# CAP 1732 CAST re-cap

# About the workshop

# Purpose of the workshop:

- To **discuss and gather feedback** on items that should be **updated and/or included** in a future edition of *CAP 1732 Aerodrome Survey Guidance*.
- We asked – You said – We did

# Areas prior to the runway being included in runway dimension: Starter extension & yellow chevron area.

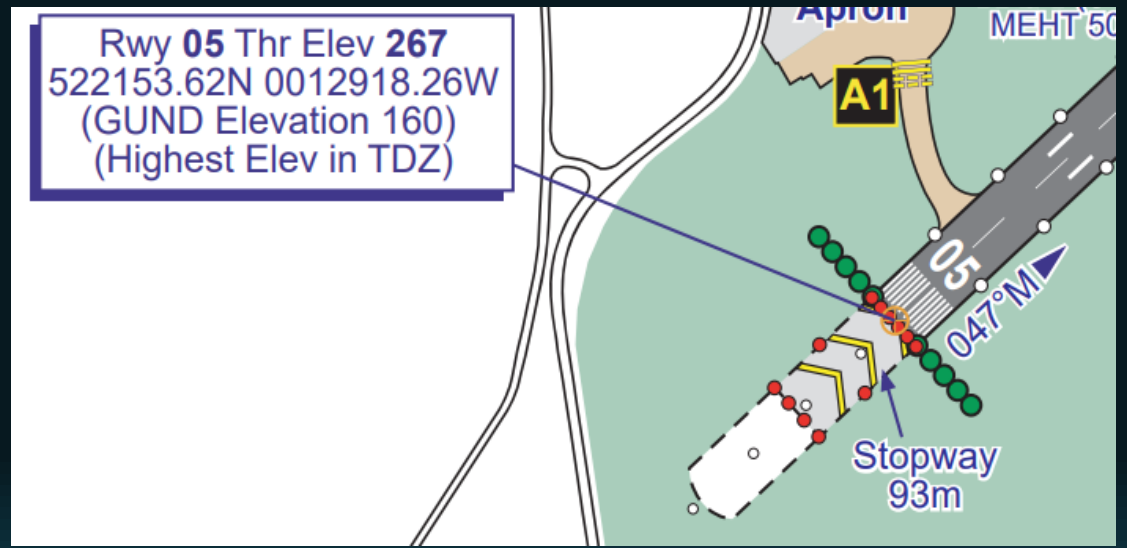
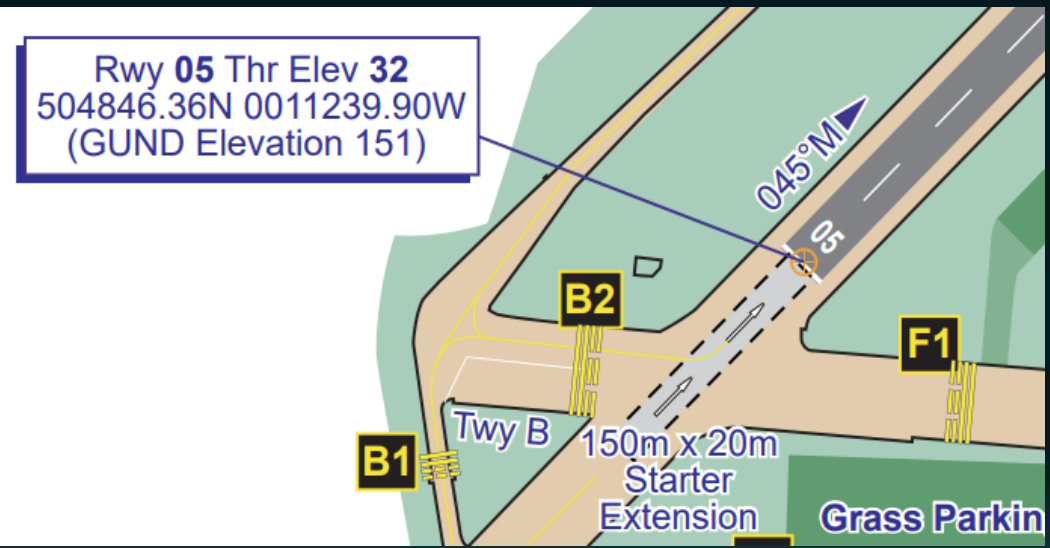
*Note: This is not a current issue. All prior cases have been resolved; however, it remains still as a potential to re-occur so this is just an awareness it has been a cause of high time consumption and to recommend further definitions where a quick reference can resolve.*

There is a feeling that the airport sponsors sometimes try to influence the outcome for runway dimensions. There may even be grey areas where they have a good case. But when it comes to AIS cartography an illustration must have a very clear set of guidance where no conflict in specification occurs, and the plan aligns to the declared distance data. Generally, from CAA specification guidance, starter extensions are not part of the runway, due to having lesser width, and therefore not part of the dimension, we draw them differently to stand out this way. Yellow chevron areas are also not part of any manoeuvring area and are not part of the runway dimension.

EGEC AD 2.16 HELICOPTER LANDING AREA

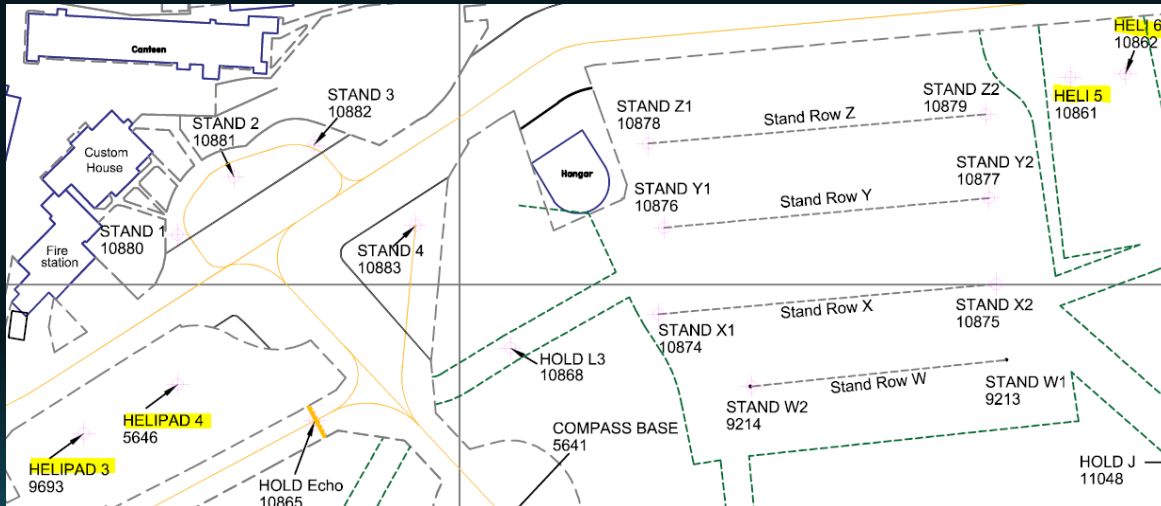
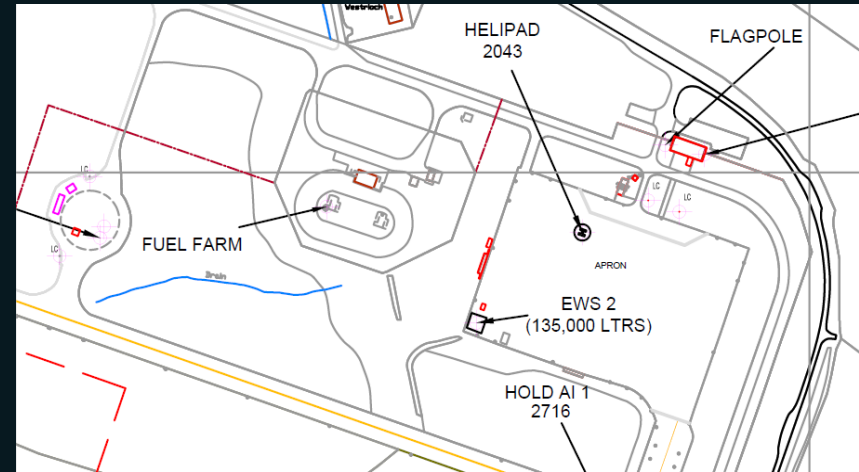
Is there CAA minimum spec for a heli landing sites so AIS can identify an AD 2.16 facility?

Should heli landing sites be surveyed in higher detail as per runways?

>Markings (colour and line thickness) as per real world.

>Coordinates for TLOF centre, FATO thresholds, bearings, dimensions.

>Minimum lighting requirement?

# Observed vs reported values – concept of retaining reported values when observed values are within a tolerance

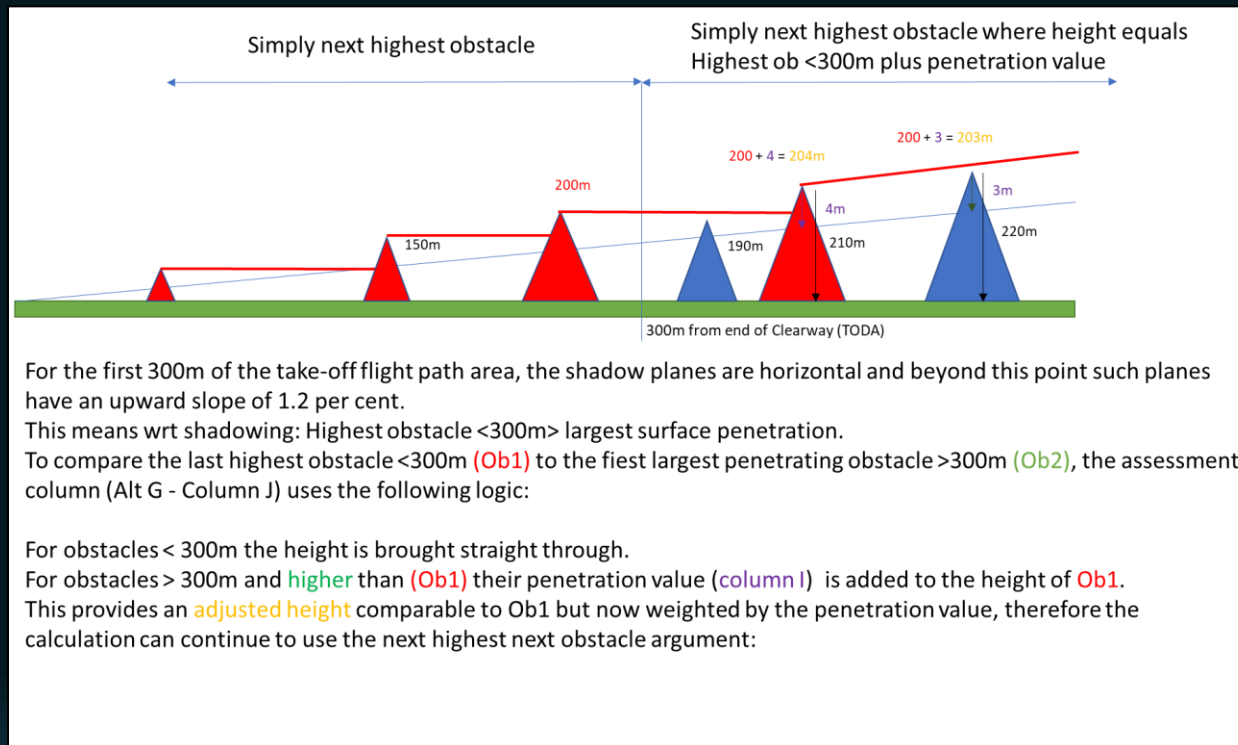
e.g. EGTU Dunkeswell 2024 Survey:

# Obstacle Free Zone (OFZ) definitions and dimensions from Survey reports (slide 1 of 2)

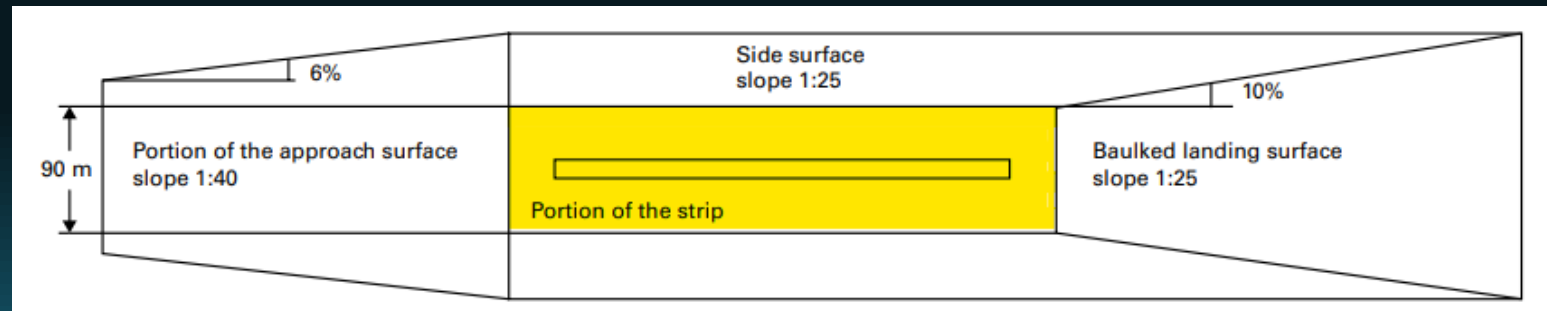
Only mention of OFZ in CAP 1732:

ICAO PANS-AIM Document 10066 - AD 2.12 requirement:

13) the existence of an obstacle-free zone; and
